Access Compliance Report Public Rights-of-Way (Curb Ramps)

Main Street: ST_IVES_WAY Cross Street: ST_JUST_ST Location: SE

ADA ID: RPRK211115115342 Ramp Type: Type 4 - Parallel Initial Pass/Fail: Pass Overall Compliance: No Severity Score: 25

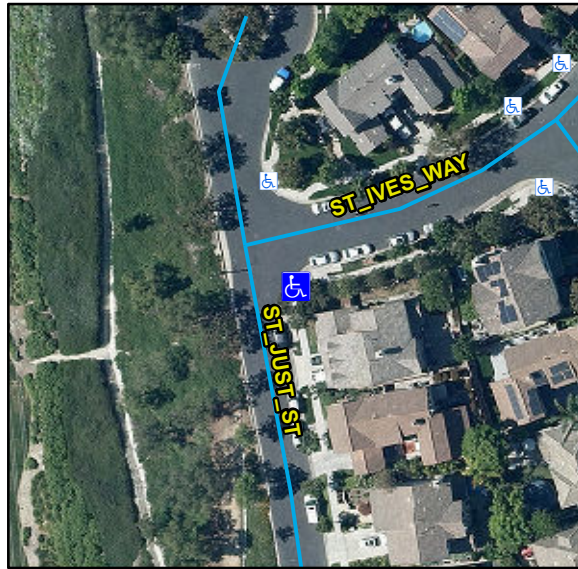
Compliance	Description	Data	Compliance	Description	Data
N/A	Ramp Length LT (in)	136	N/A	Ramp Length RT (in)	140
Yes	Ramp Width LT (in)	53	Yes	Ramp Width RT (in)	53
Yes	Ramp Run Slope LT (%)	1.4	Yes	Ramp Run Slope RT (%)	7
Yes	Ramp Cross Slope LT (%)	0.3	Yes	Ramp Cross Slope RT (%)	1.1
N/A	Landing Present	No	No	DWS Provided	No
N/A	Landing Length (in)	N/A	N/A	DWS Contrast	N/A
No	Landing Width (in)	N/A	N/A	DWS Length (in)	N/A
No	Landing Run Slope (%)	N/A	N/A	DWS Full Width	N/A
No	Landing Cross Slope (%)	N/A		DWS Offset Type	N/A
N/A	Landing Movement Obstructed?	No	N/A	DWS Offset Left (in)	N/A
	Landing Movement Type	Curb	N/A	DWS Offset Right (in)	N/A
N/A	Landing Shared	N/A			
N/A	Clear Space	Yes			
N/A	Clear Space To Crosswalk (in)	48			
N/A	Marked Crosswalk 1	No	N/A	Marked Crosswalk 2	No
	Crossing 1 Direction	N		Crossing 2 Direction	W
	Marked Crosswalk 1 Width (in)	N/A		Marked Crosswalk 2 Width (in)	N/A
N/A	Ramp Inside Crosswalk 1	N/A	N/A	Ramp Inside Crosswalk 2	N/A

Crossing 1 Slope (%)	3.1		Crossing 2 Slope (%)	0.2
	Crossing 1 Cross Slope (%)	2.4		Crossing 2 Cross Slope (%)	0.3
Yes	Gutter Ponding	No	Yes	Curb Slope	4.3
Yes	Gutter Lip Height (in)	0		Road Run Slope (%)	3
No	Gutter Run Slope (%)	14		Road Cross Slope (%)	0.2
Yes	Gutter Cross Slope (%)	2.7	No	Perpendicular Joint Present	No
Yes	Overall Surface Condition	Acceptable			
	Cross Gutter Present?	No		Spandrel Present?	No
	Replace Cross Gutter?	N/A		Replace Spandrel?	N/A

Remove & Replace Curb Ramp With Two New Directional Ramps or Equivalent. Remove & Replace Gutter.
